BACKGROUND REVIEW
URBAN DESIGN & TRAFFIC ENGINEERING

To:	Peter Douglas	Date:	March 2019
Company:	Mildura Rural City Council	From:	Hansen Partnership
Cc:			
Re:	Mildura South NAC Stage 1: Background Review

**RE: Mildura South Neighbourhood Activity Centre
 Traffic Engineering Advice and Design Parameters**

Figure 1: Mildura NAC

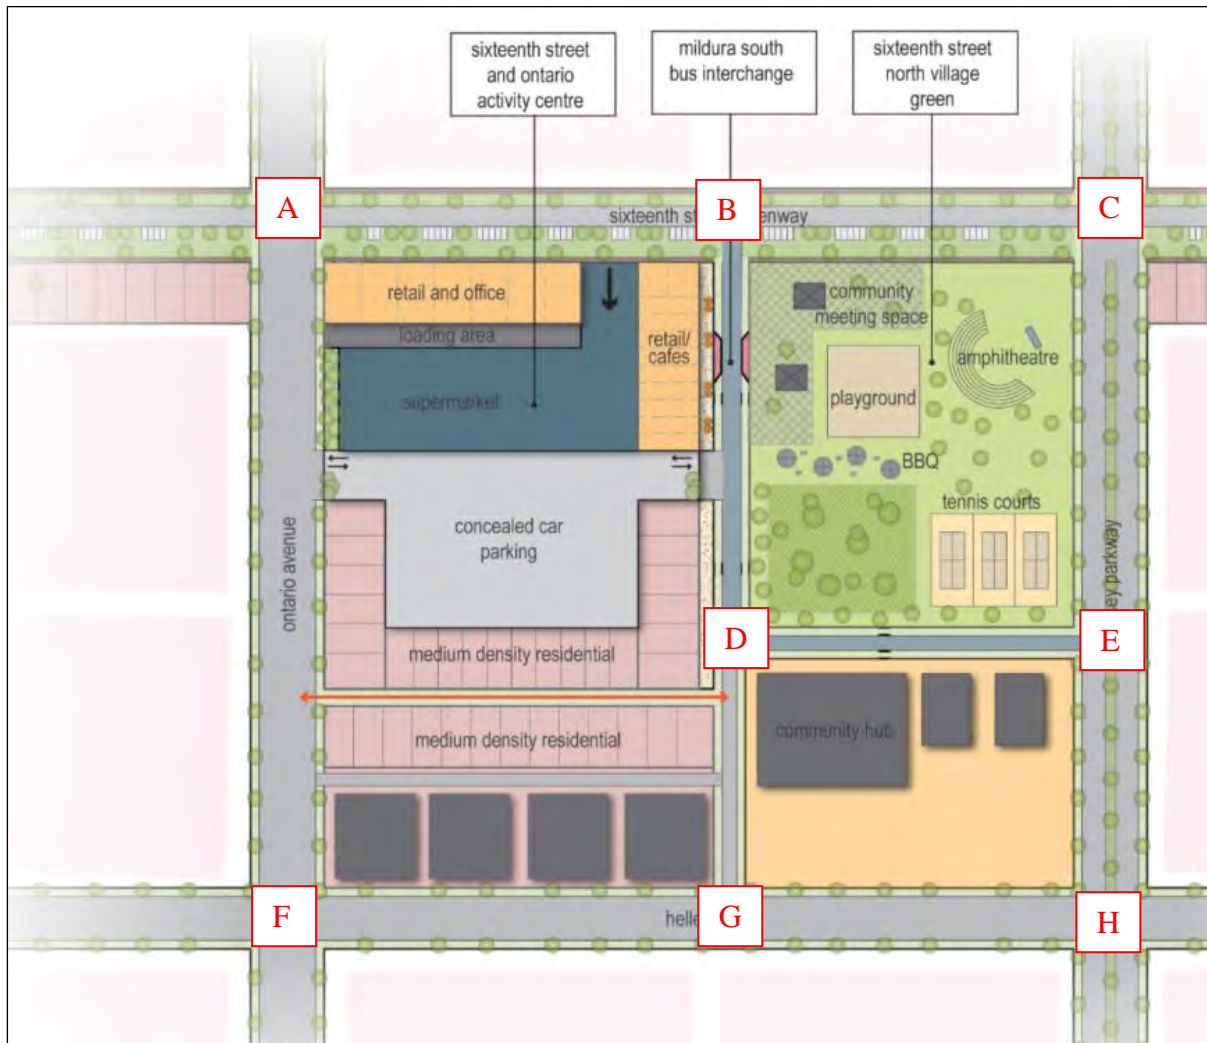
- Ontario Avenue (A to F)
 - Designated as an “Access Avenue” in the Mildura South PSP, which aligns with a Connector Street cross section (undivided road), including parallel car parking and bus stops.
 - As per the Mildura Planning Scheme, bus stops should be provided kerbside (rather than indented).
 - Primary access to the off-street car parking area should be via Ontario Avenue, rather than the NAC Access Road.
 - On-street loading opportunities for the retail stores and offices fronting Sixteenth Street Greenway could be provided via Ontario Avenue.
 - Access to the supermarket loading bay will be via Ontario Avenue. This access should be designed to ensure vehicles can both enter and exit the loading bay in a forward direction (i.e. not required to reverse from Ontario Avenue).

- Direct access onto Ontario Avenue from medium density residential development (townhouses or apartment complexes) would be appropriate, however, the number of crossovers should be minimised.

- Hellen Road (F to H)
 - Designated as a “Secondary Road” in the Mildura South PSP, which aligns with a Connector Street cross section (undivided road), including on-road bicycle lanes and parallel car parking on both sides.

- Elsey Parkway (C to H)
 - Designated as a “Parkway” in the Mildura South PSP, which aligns with a Connector Street cross section (divided road), including separated on-road bicycle lanes and parallel car parking on both sides.

- Sixteenth Street Greenway (A to C)
 - Designated with a unique “Sixteenth Street Greenway” cross section in the Mildura South PSP, which aligns with a Connector Street cross section (undivided road), including a two-way off-road bicycle path, indented parallel car parking on one side and angled car parking on the other side.

- All bicycle and pedestrian crossing points need to be designed to ensure the priority is clear (pedestrian and cyclists or vehicles to give way) e.g. at the intersections with Ontario Avenue, the NAC Access Road and Elsey Parkway.

- NAC Access Road (B to E)
 - Designated as an “Edge Road” in the Mildura South PSP, which generally aligns with an “Access Street Level 2” cross section, but modified to include indented parallel car parking on one side (adjacent to the open space).

- This is the main roadway through the centre of the NAC. The development plans indicate a major bus terminus at its northern end.
 - On-street loading opportunities will need to be provided for the abutting retail stores.

- Consideration to be given on providing a 40 km/h speed limit. Bus friendly traffic calming devices can be considered to assist in managing speeds.
 - The PSP indicates that on-street car parking will be provided along one side only, adjacent to the park. Convenient on-street car parking should be maximised adjacent to the retail stores and community facilities. This is particularly important

- Secondary access to the off-street car parking area should be via the NAC Access Road.
- It is unclear if an off-road bicycle path will be included within the open space, however if not, cyclists will be required to share the carriageway with vehicular traffic.

- NAC internal north - south road (D to G)
 - This roadway is not specifically mentioned in the Mildura South PSP, but it is expected to be similar to the “local road” layout, which generally aligns with an “Access Street Level 2” type cross section and modified to include a wider carriageway width.

- This roadway is not considered integral in providing vehicle access through the NAC, and therefore consideration could be given to designating this section of road as a shared area, with priority given to pedestrians and cyclists rather than vehicular traffic and a speed limit of 10 – 15 km/h applied. Implementation of a shared zone will need to be complimented with landscaping and contrasting pavement material in order to create a slow speed environment.

- East-West Laneway
 - This roadway is designated as a “Rear Access Lane” in the Mildura South PSP, which align with an “Access Lane” type cross section, with no parking or footpath provision.

- Some medium density lots will have no access to the laneway and access will be via “concealed car parking” area. Access to residential lots from a public car parking area is not acceptable and the proposed medium density development should be redesigned to avoid this.
